PREVOST

WARRANTY BULLETIN

WB15-14

DATE :	APRIL 2015	SECTION :	04 - Exhaust
EXPIRATION:	APRIL 2017		
SUBJECT :	EXHAUST DIFFUSER DRAIN TUBE

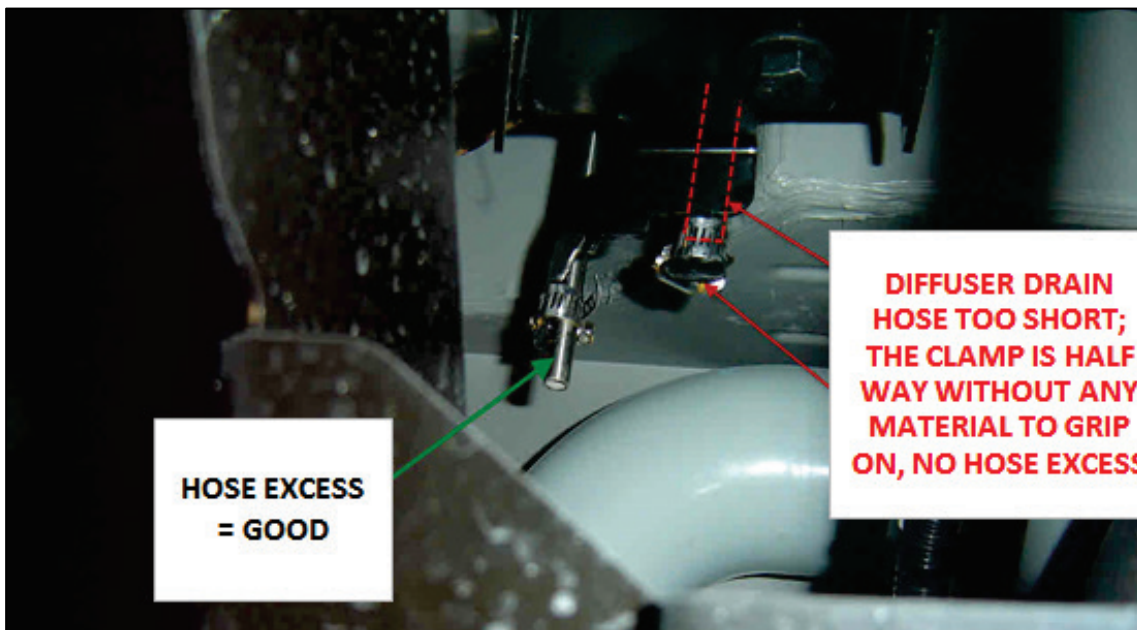
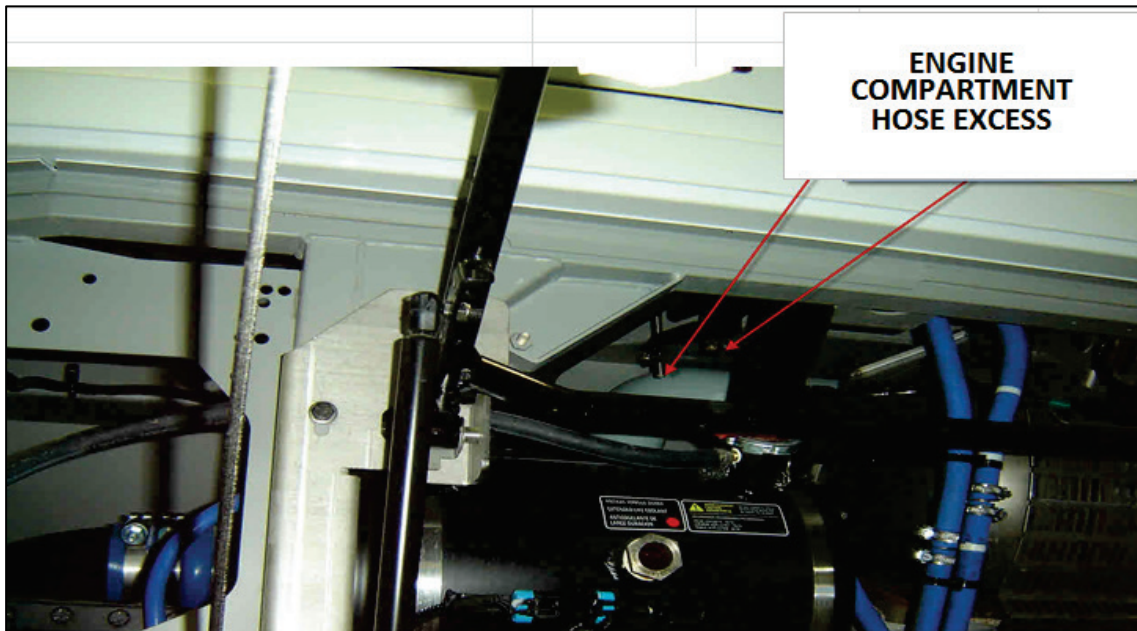
On the vehicles affected by this bulletin, the end of the exhaust diffuser drain tube may not be properly attached.

Part No.	Description	Qty
5011119	ADAPTER / 1/2NPT-Fx1/2NPT-M	1

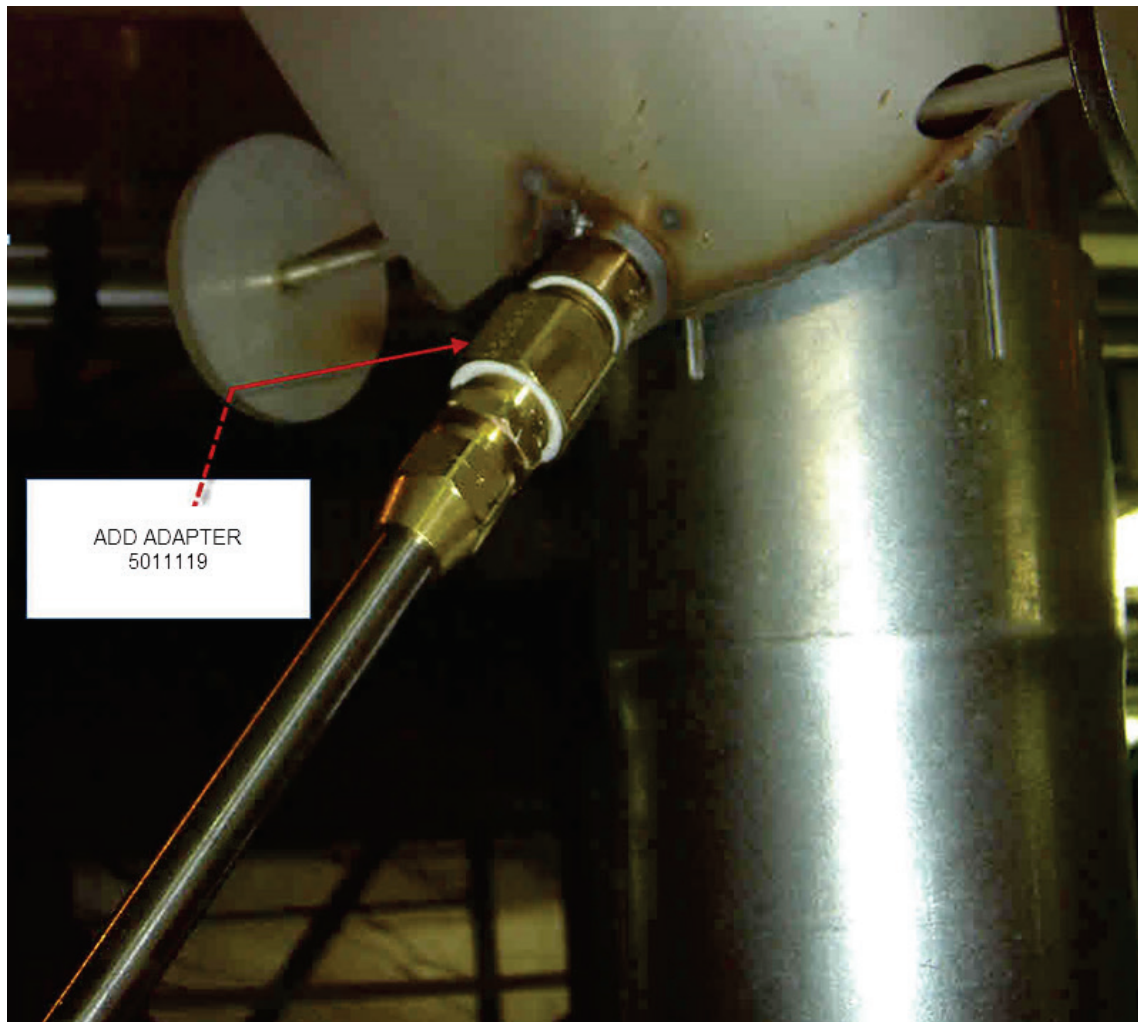
1. In the engine compartment, inspect the lower part of the diffuser drain tube and make sure there is an excess length allowing proper seating of the clamp.
2. If it is not the case, unscrew the clamp to free the tube.

3. Add adapter #5011119 to the upper connexion.
4. Re-tighten lower clamp.
